Contract Change Order # 1

Project Name: Albany Street Southside Drainage Imp. Project Number: 104283
Project Location: Albany between 9th St. & County Line Date of Application: Tuesday, April 2, 2019
Contractor: Cherokee Pride Construction Submitted By: Harlan Y.

Project Name: Florence Street Bridge Repair over Creek Turnpike Project Number: ST1938
 Project Location: Florence Street - between Olive and Garnett Date of Application: Thursday, February 21, 2019
 Contractor: Cherokee Pride Construction Submitted By: Harlan Y.

WEST APPROACH SLAB PLAN

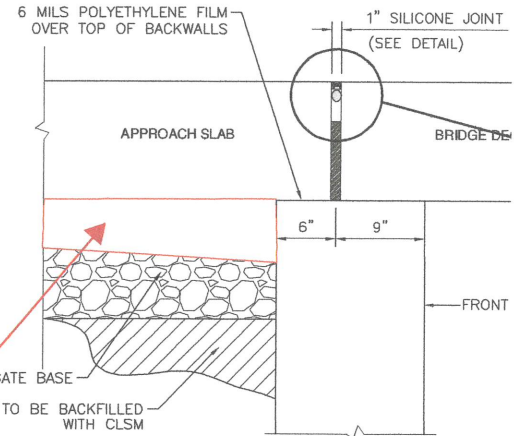
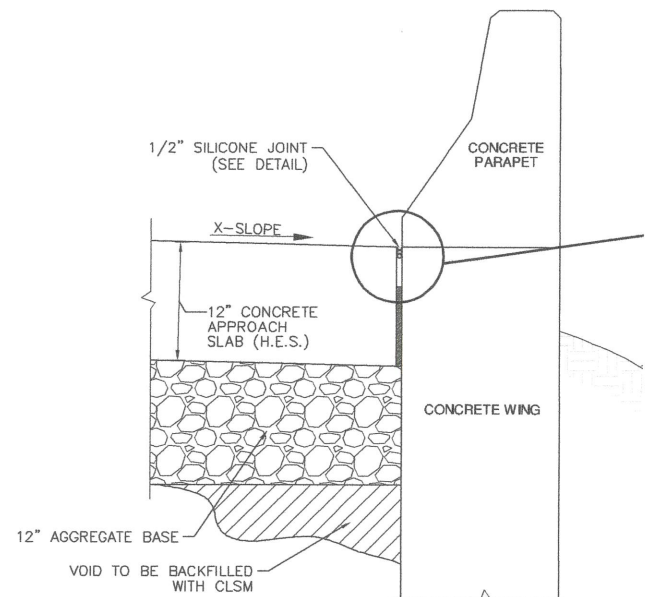
- During the excavation of the existing bridge approach concrete pavement over the existing known void cavity, it was observed that the abutment backfill on the west side of the bridge has settled. The attached detail shows the extents of the void cavity identified. Uretek - USA has reviewed the situation and provided a cost proposal to inject High Density Polyurethane into the void cavity from the surface of the existing pavement. This void fill is estimated at 1500lb of material and injection processes shall not exceed this amount. The contractor shall utilize this sub-contractor to perform this void fill operations and the below costs summarize the complete in place operation.

- 1) USA has reviewed the situation and provided a cost proposal to inject High Density Polyurethane into the void cavity from the surface of the existing pavement. This void fill is estimated at 1500lb of material and injection processes shall not exceed this amount. The contractor shall utilize this sub-contractor to perform this void fill operations and the below costs summarize the complete in place operation.
